FINAL ENVIRONMENTAL IMPACT REPORT

Washington Square Mixed-Use Development

ENV-2007-5046-EIR

Figure 25
Existing and Computer Rendered
Views from Washington Boulevard
Alternative C

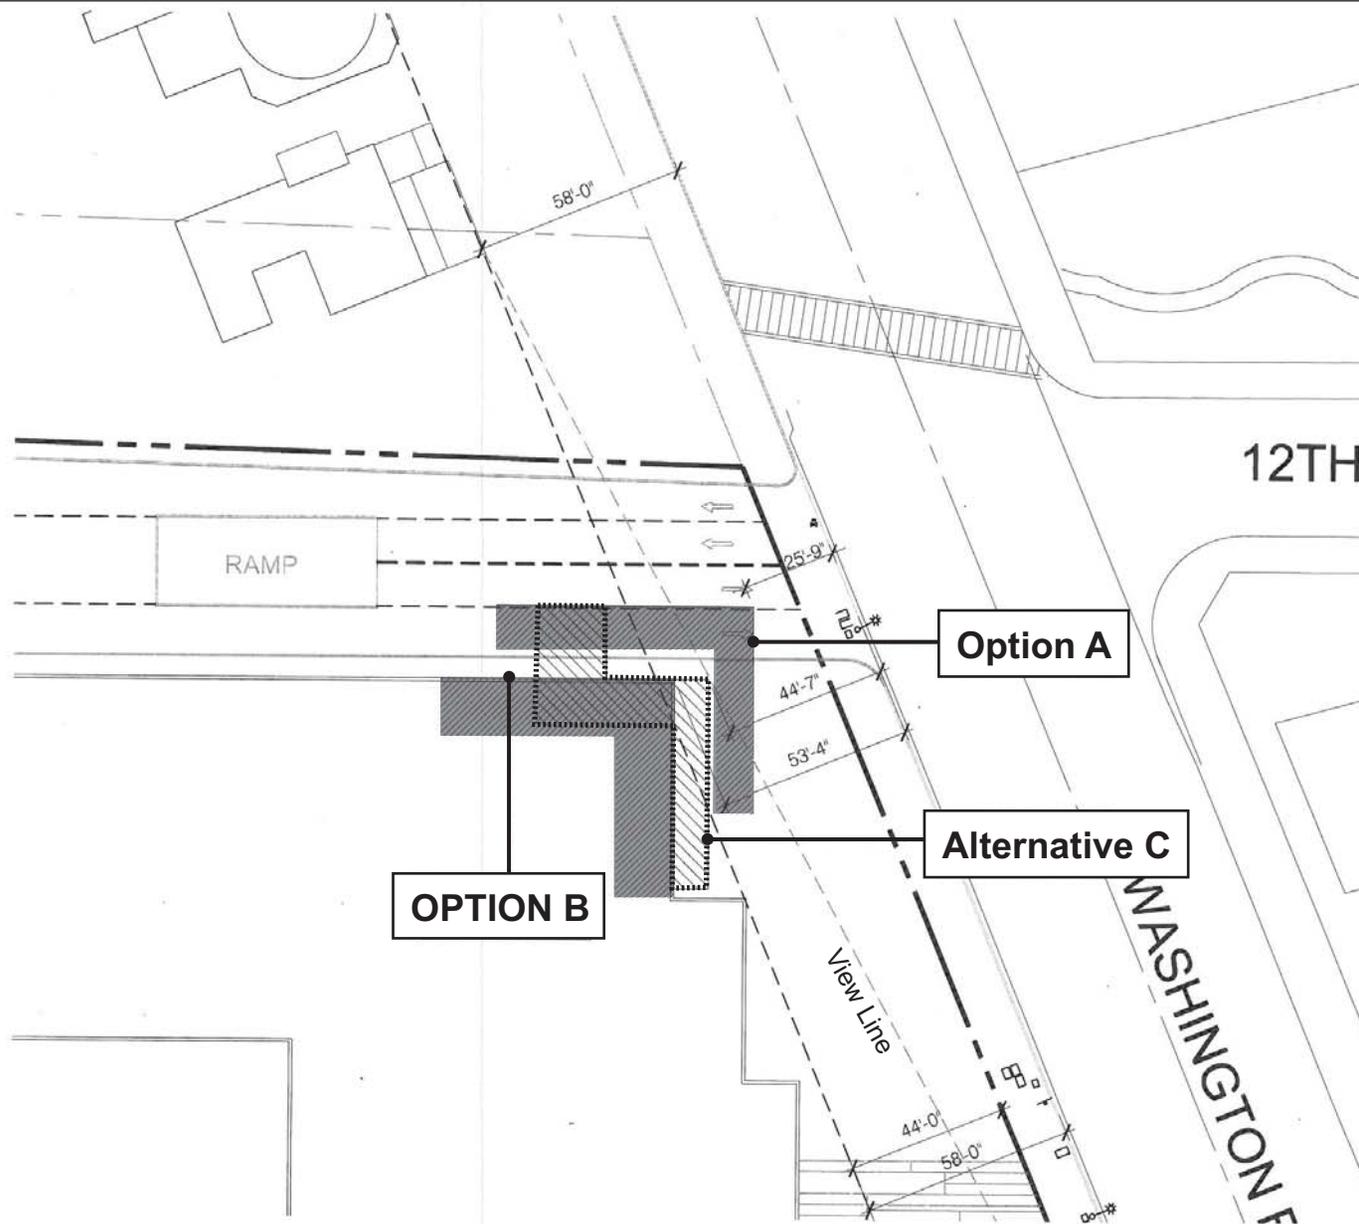
Although I was unable to determine the actual proposed front setback of Building-C, Option-A from the DEIR it appears from my interpolation of the dotted and dashed setback lines on Figure V-3 to be approximately 15-feet. This would imply therefore that the announced change to a 40-foot setback is in reality only a further setback of an additional 25-feet. This 25-feet of setback is literally sliced off from the façade of Building-C Option-A and added to the top of the structure thereby increasing it from 18 to 20-stories and at 230-feet in height.

Statement No.3, "By locating the greater height further south on the site, as shown in Figure V-3, views to the adjacent St. Paul Catholic Church would be maintained" is fallacious. The additional increase in the front setback by another 25-feet does nothing meaningful to maintain the

Setting back the tower 40 feet from Washington Boulevard and aligning it to the setback of St. Paul's Rectory, would provide a meaningful increase in the viewshed when travelling west on Washington Boulevard just east of the proposed project. Views of St. Paul's Catholic Church and Rectory from Washington Boulevard are significantly greater in Alternative C compared with Option A. Figure 25, *Existing and Computer Rendered Views from Washington Boulevard - Alternative C* demonstrates the view of St. Paul's Catholic Church that would be available, with the implementation of the building setback under Alternative C. As shown in Figure 25, the Church steeple and Rectory would be substantially visible from Washington Boulevard. Figure 26, *Building Setbacks under Option A, Option B, and Alternative C*, provides a comparison of the

various dimensions represented in the simulated figures. Please also see Figure 25, above, and Figures 9 and 10, in Response to Comment No. 6-3.
